Project Name 83 Main Street
Town Ludlow County Windsor
State Agency AAA Act 250 # pre-app

DIVISION FOR HISTORIC PRESERVATION
Preserving Vermont's historic, architectural and archeological resources

Re: 83 Main Street, Ludlow. Pre-Act 250.

Richard HARRISON
83 MAIN ST.
Ludlow, VT.
1st FLOOR $\frac{1}{4}'' = 1 \text{ FOOT}$

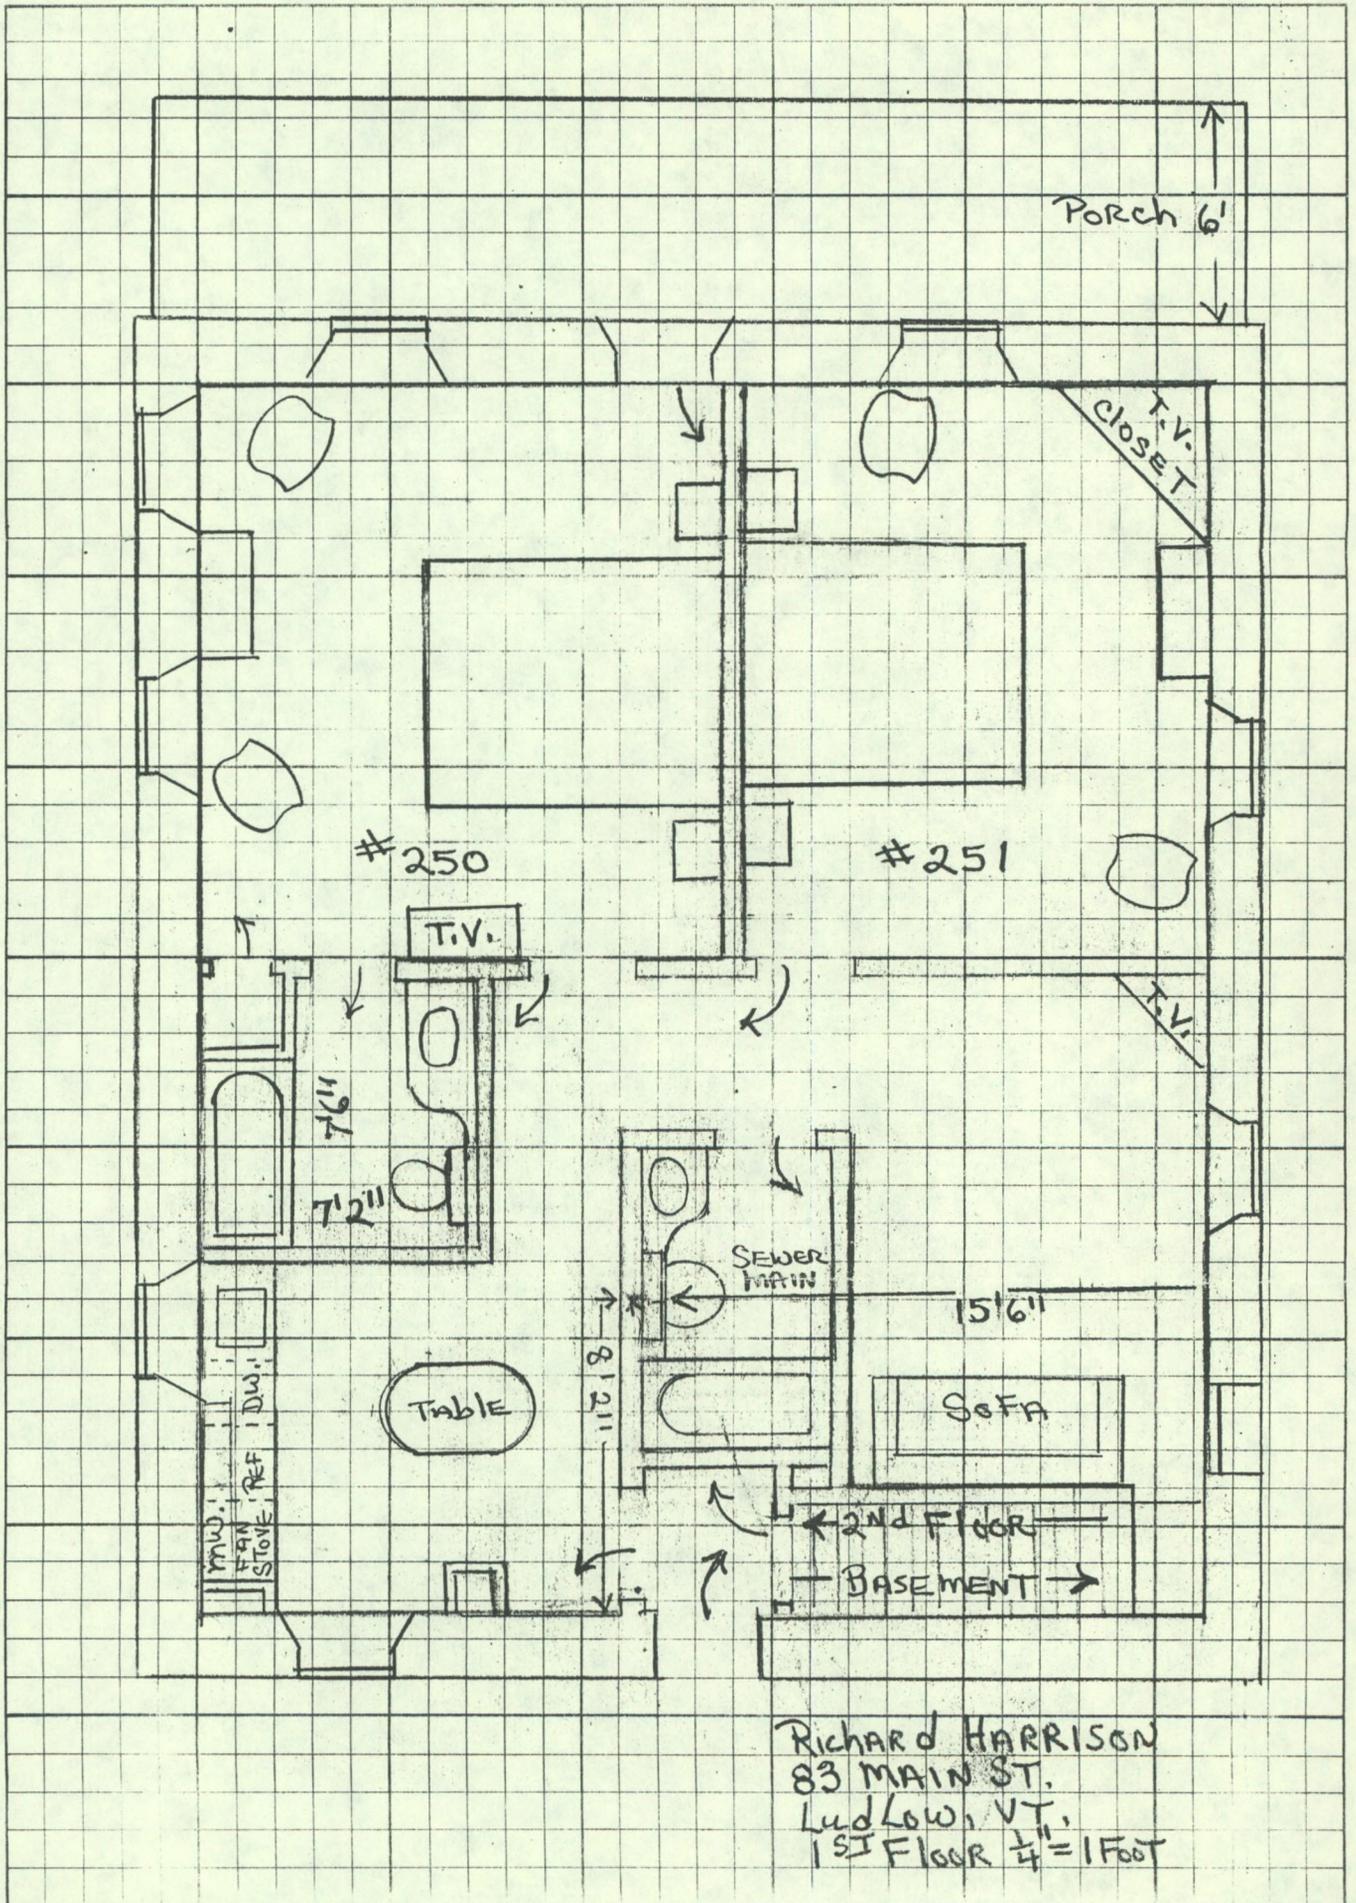
- 4) The sliding, paneled "pocket doors" dividing the two front rooms on the first floor shall remain in place and, due to the need to fire-proof and sound-proof each unit, may either be fixed and left exposed on one side (in either room, with the opposite wall built-out for sound and fire proofing) or covered in place in a manner that will allow them to be uncovered and again function at some future time. (The pocket doors are the most significant feature of the building's interior and should be retained in place since all other significant

interior features (except window surrounds and reveals) must be changed to accommodate the project. Moving the doors to another part of the building will not preserve them as a significant, original interior feature. We strongly encourage that the pocket-doors be left exposed on one side, but enclosing them in a reversible manner will adequately preserve and protect them.)

While it is clearly the best preservation option to leave the pocket doors in place and visible from at least one side, I recognize that you believe that it will be more difficult for you to structurally reinforce the section of wall and to provide an effective sound barrier between the motel rooms. However the use of these doors elsewhere in the building is marginally acceptable provided documentation of the original location through high-quality photographs and text is displayed in all three affected locations.

Richard HARRISON
83 MAIN ST.
Lud Low, VT.
3rd FLOOR 1/4" = 1 FOOT

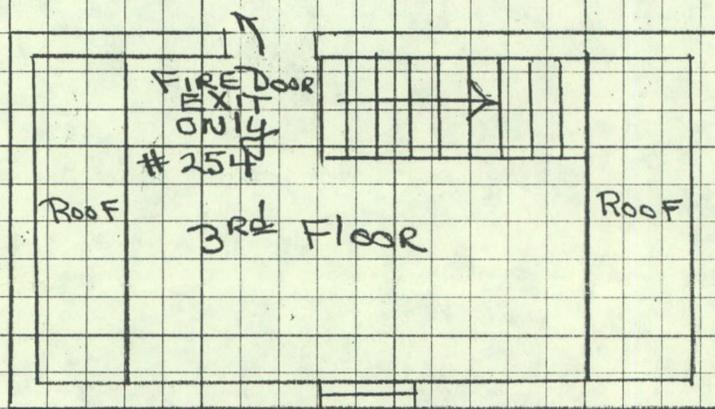
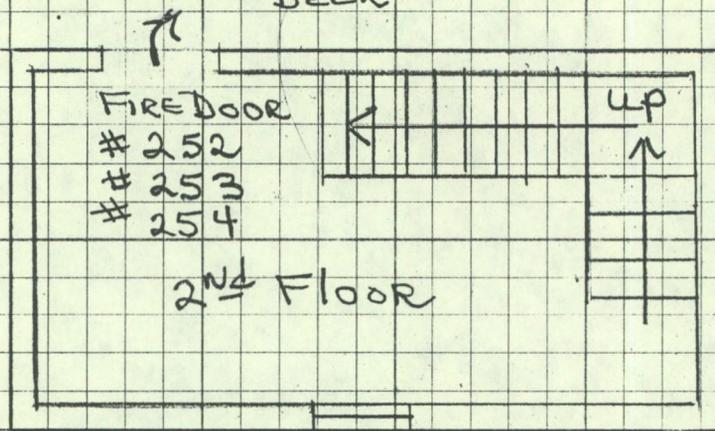
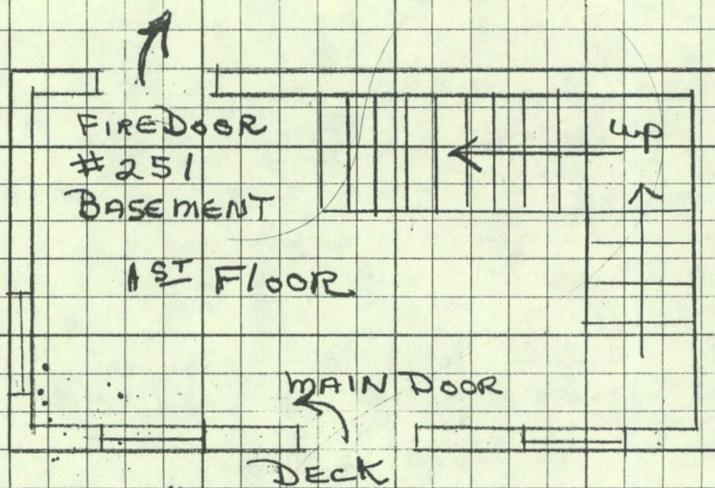
- 2) The rear ell shall retain its clapboard siding and not be vinyl sided, and its existing door and window on its east side shall be sealed and retained consistent with fire safety standards. (An existing north entry in this addition is being removed and a new entry added, and the interior of the addition and its framing altered. Retention of the clapboard siding and more publicly visible east entry and original 6-over-6 sash window will adequately maintain the historic character of this original ell.)

We are now in agreement that there will not be vinyl siding on the rear addition.
